Annex III

to Task 7 ENTR Lot 6 Ventilation Final Report

Stakeholder Input

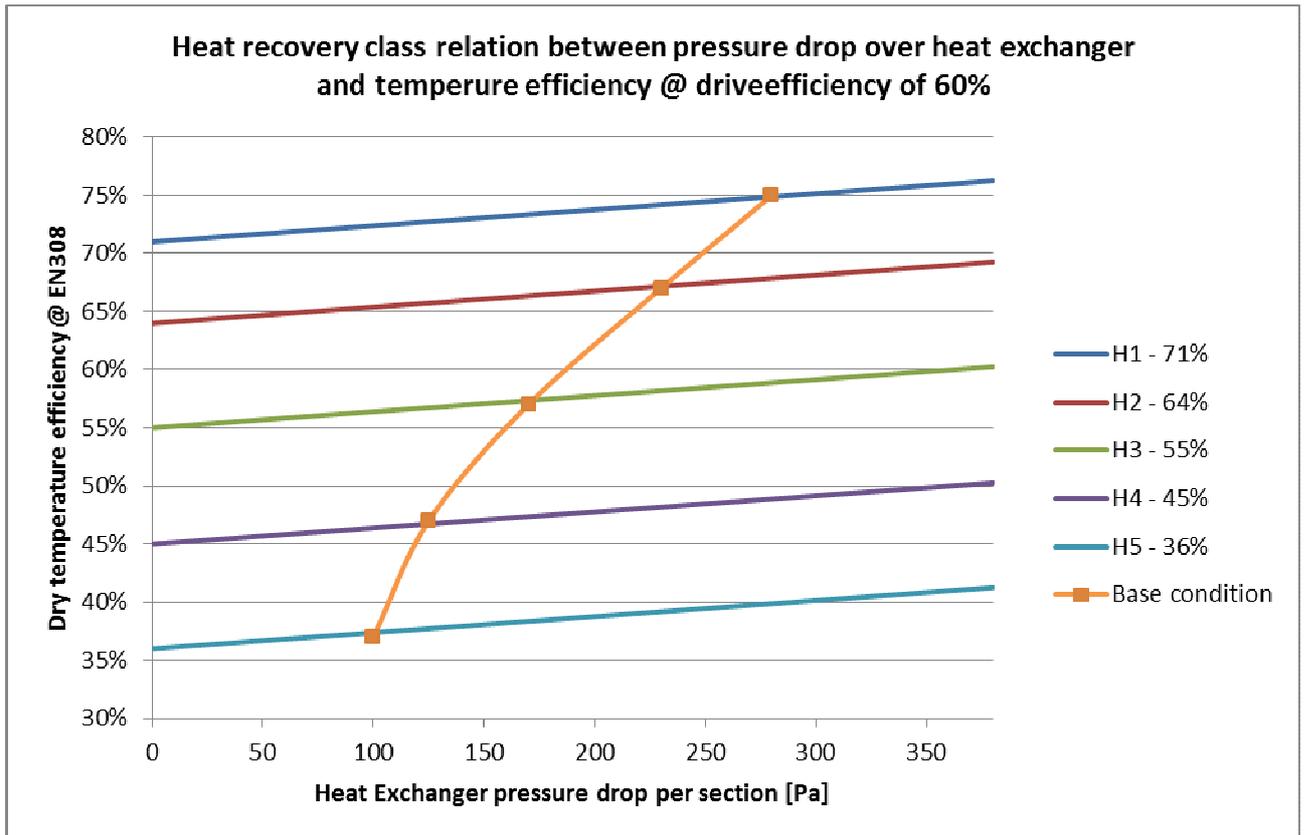
Velocity class grouping do not correspond to the heat recovery class, temperature efficiency and corresponding pressure drop.

As the table shows there is no relation between the velocity over the heat recovery system and the heat recovery class's, temperature efficiency and the corresponding pressure drop from the real world, this is not a final proof, but just an indication of the problem with using the velocity as the main figure.

The velocity class idea is good as long as this is covering all components from ducts, filters, heat recovery, coils etc. as the change in velocity from one component to another is energy consuming which is not taken into account in EN13053.

Fan power consumption

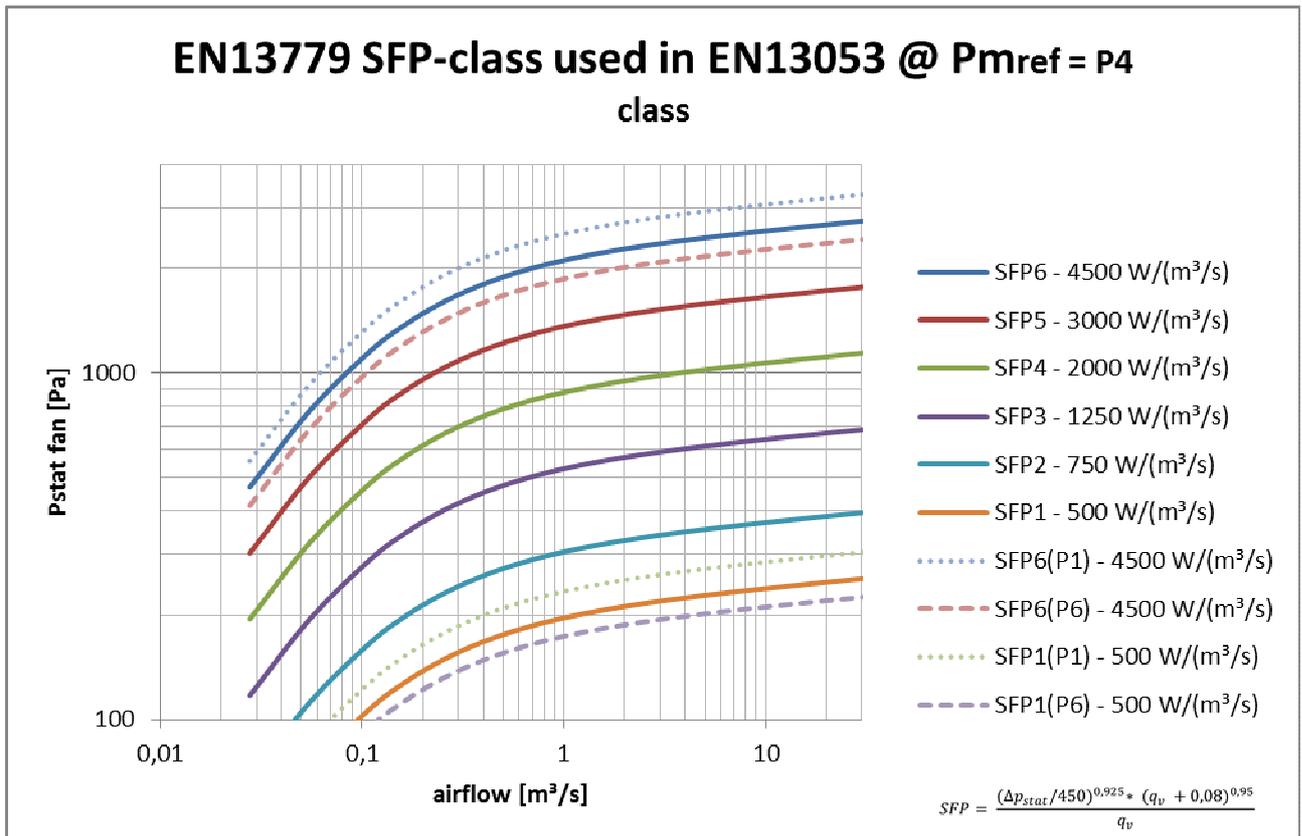
Below is how EN13053 converting of the pressure drop and temperature efficiency is directly linked to the fan system efficiency, there the design condition is based on a drive efficiency of 60% which is a high figure for system running on low pressure, which can be seen in the following.

EN13053 do not care why the unit has to use a high pressure, if this is caused by the function of the unit or the external requirement for ductwork etc. EN13053 is purely focusing on efficiency in balance between pressure and airflow.

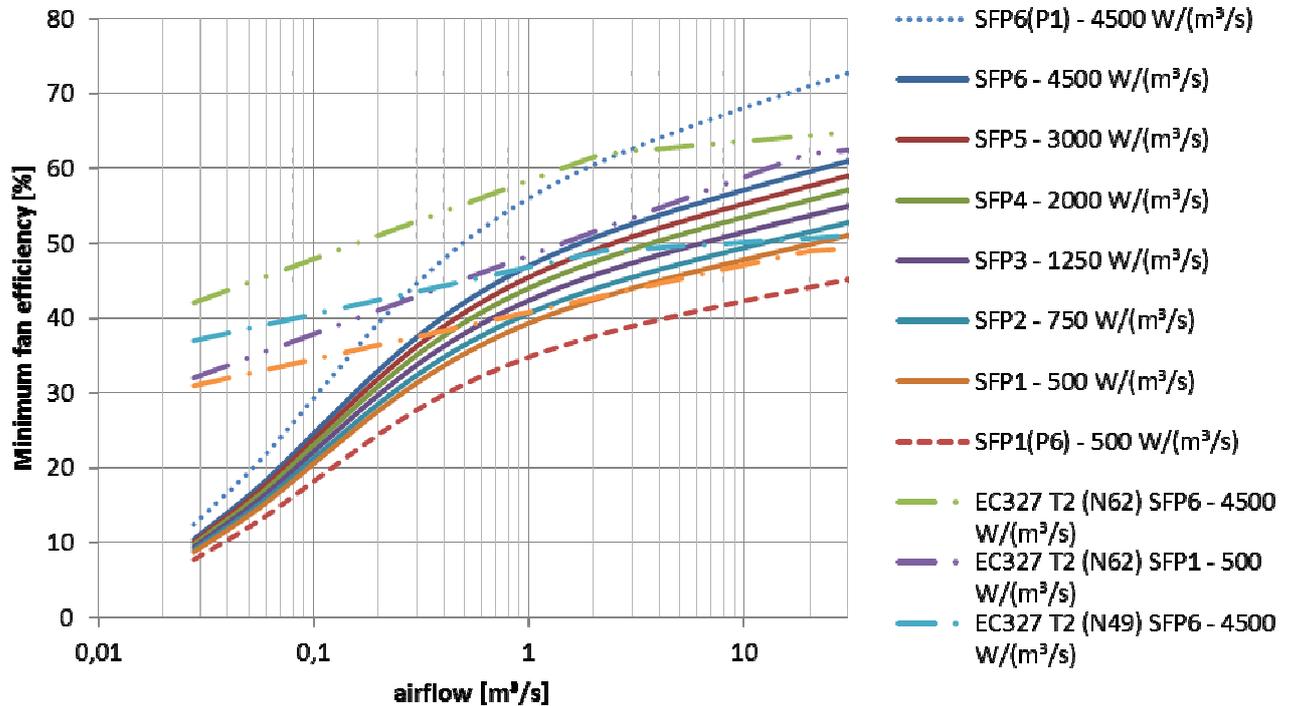
If we take a look on the SFP-class from EN13779, where SFP6 is using 9 times more energy than SFP1 and use these values to calculate pressure requirement by using the formula for P-class in EN13053, which is equation power class P4 in the EN13053.

As it can be seen from the curves above the pressure increase from SFP1 to SFP6 is more than 10 times, which means that the efficiency of the fan system has to increase with the pressure load as the cost was only 9 times.

Two extra lines are drawn for P1 and P6-class for comparing, which represent a 15% improvement and 12% reduction compared with P4.

No. 2

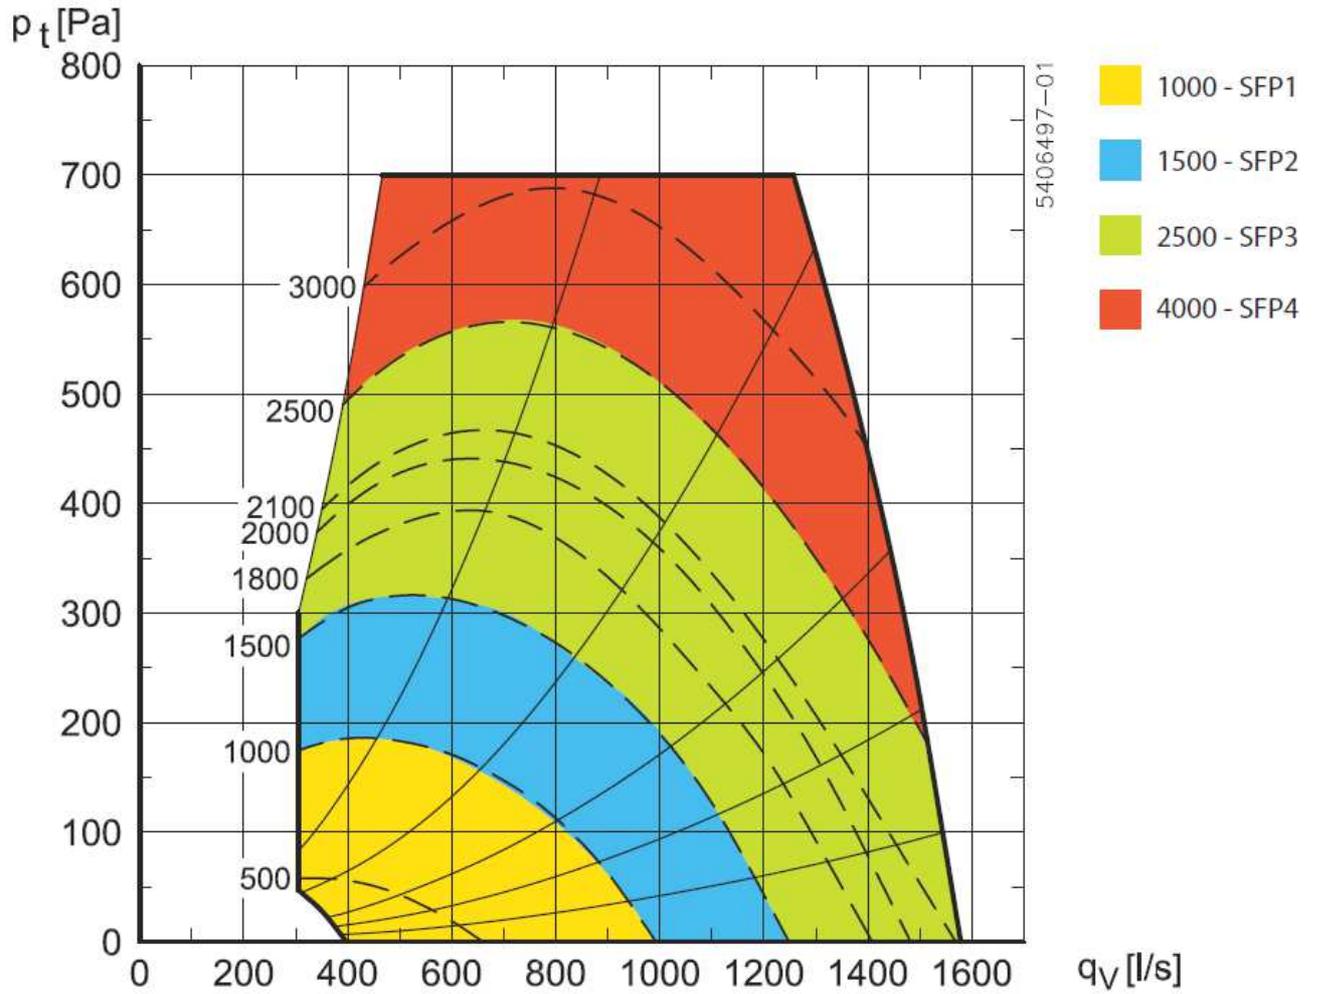
One main problem with EN13053 is that it is only focusing on one working point, which must be known to do the calculation, but there are also many standard products sold on the market, where we as manufacturer do not know the working point of the unit and therefore describing the performance data on the base of SFP-values, which makes it possible for the client to select the most economic unit for his use. This model is integrated into all Scandinavian countries' legislations and the Passivhaus standard.

Above figure is showing such diagram, which then make it possible to describe that this unit in the area below the red area will fulfill a requirement of maximum SFP3 = $2500 \text{ J/m}^3 = 2.5 \text{ kW}/(\text{m}^3/\text{s})$.
